# UNITED STATES PATENT AND TRADEMARK OFFICE

APPLICATION NO.	FILING DATE	FIRST NAMED INVENTOR	ATTORNEY DOCKET NO.	CONFIRMATION NO.
10/824,229	04/14/2004	Keishi Inoue	09792909-5867	6345
26263	7590	09/08/2006	EXAMINER	
SONNENSCHEIN NATH & ROSENTHAL LLP				DOAN, THERESA T
P.O. BOX 061080				
WACKER DRIVE STATION, SEARS TOWER				
CHICAGO, IL 60606-1080				
				2814
ART UNIT PAPER NUMBER

<b>Office Action Summary</b>	Application No.	Applicant(s)
	10/824,229	INOUE, KEISHI
	Examiner Theresa T. Doan	Art Unit 2814

FIG. 1.

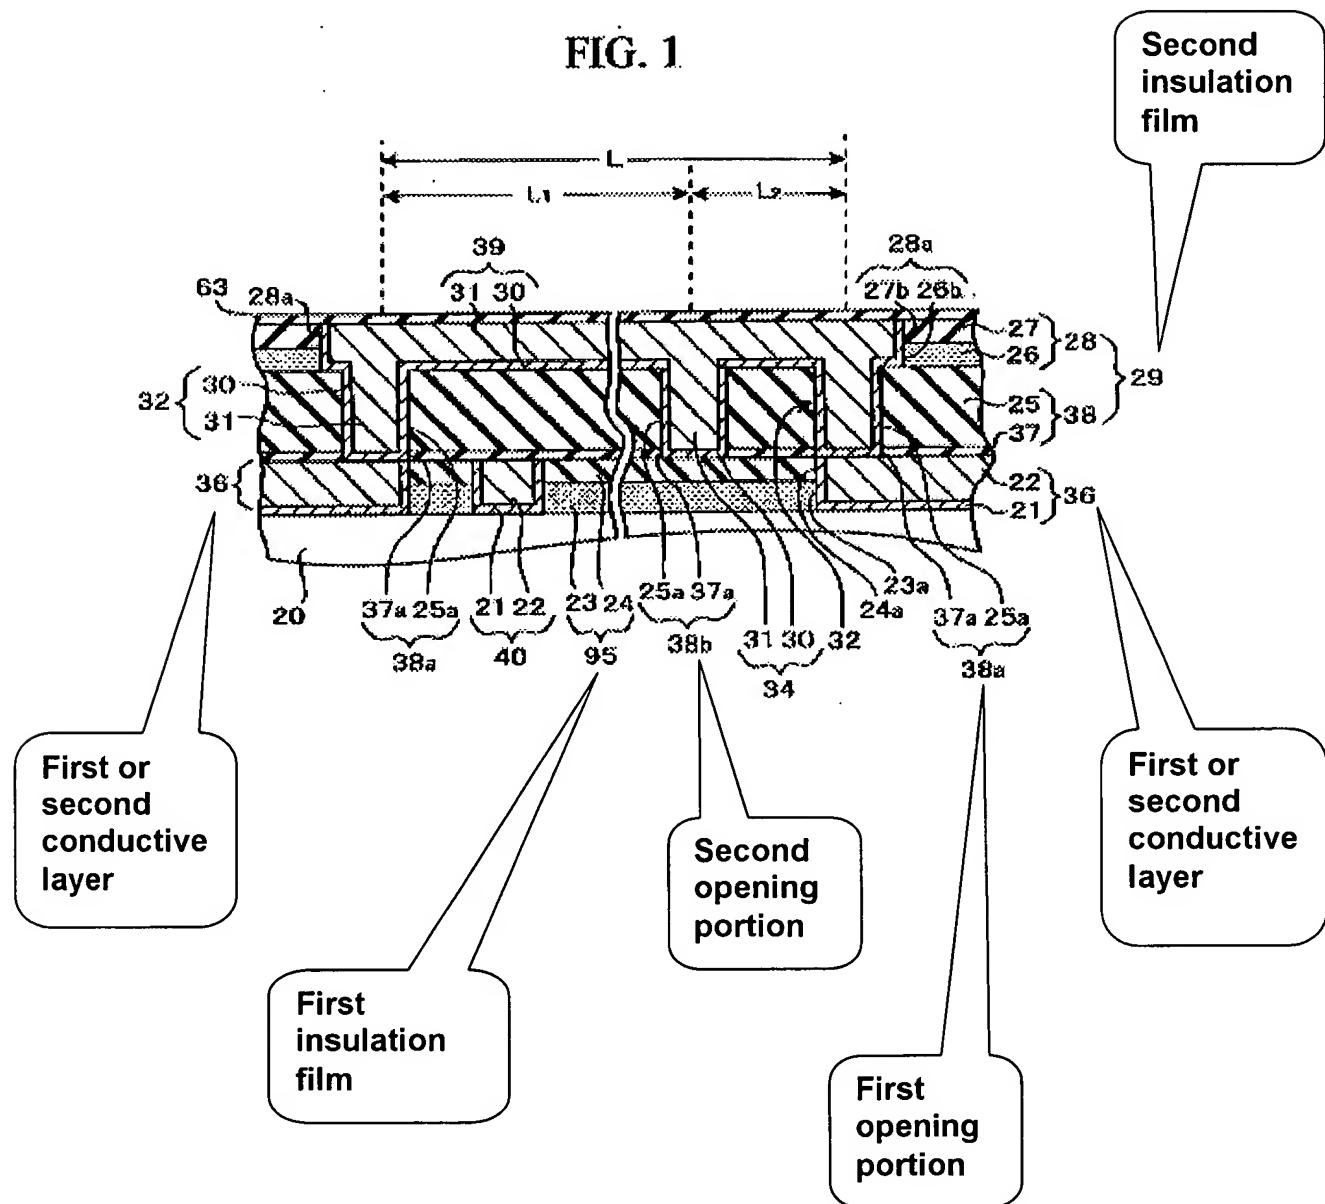
However, Watanabe (Fig. 1) discloses a semiconductor device comprising: a first insulation film 95 formed on the substrate 20 (paragraph [0061], lines 6-11); a first conductive layer 36 formed on the substrate 20 (See Fig. 1 Labeled by Examiner below and paragraph [0064], lines 2-4); a second conductive layer 36 formed on the substrate 20 (paragraph [0064], lines 2-4); a second insulation film 29 (paragraph [0066]) formed on upper surfaces of the first and second conductive layers 36 and having a plurality of first opening portions (28a,38a) (paragraph [0067], lines 1-2) to expose either the first

conductive layer 36 or the second conductive layer 36 and one or more second opening portions 38b to expose neither the first conductive layer nor second conductive layer 36 and expose the first insulating film 95; and a third conductive layer 31 (paragraph [0068], lines 7-8) formed on an upper surface of the second insulation film 29 in such a manner to fill up the first opening portions (28a,38a) and the second opening portions 38b for making electrical connection between the first and second conductive layer 36 by way of the first opening portions (28a,38a); wherein the second opening portions 38b are formed between a pair of the first opening portions (28a,38a) along the third conductive layer 31 (See Fig. 1 Labeled by the Examiner below) in order to provide a semiconductor device whose stress migration resistance (paragraph [0018]).

Accordingly, it would have been obvious to modify the device of APA by forming one or more second opening portions to expose the first insulating film because such a forming one or more second opening portions to expose the first insulating film would provide a semiconductor device whose stress migration resistance, as taught by Watanabe (paragraph [0018]).

Regarding claim 2, as discussed above, Watanabe further discloses that the second opening portions 38b are formed at a predetermined distance between the first opening portions (28a,38a).
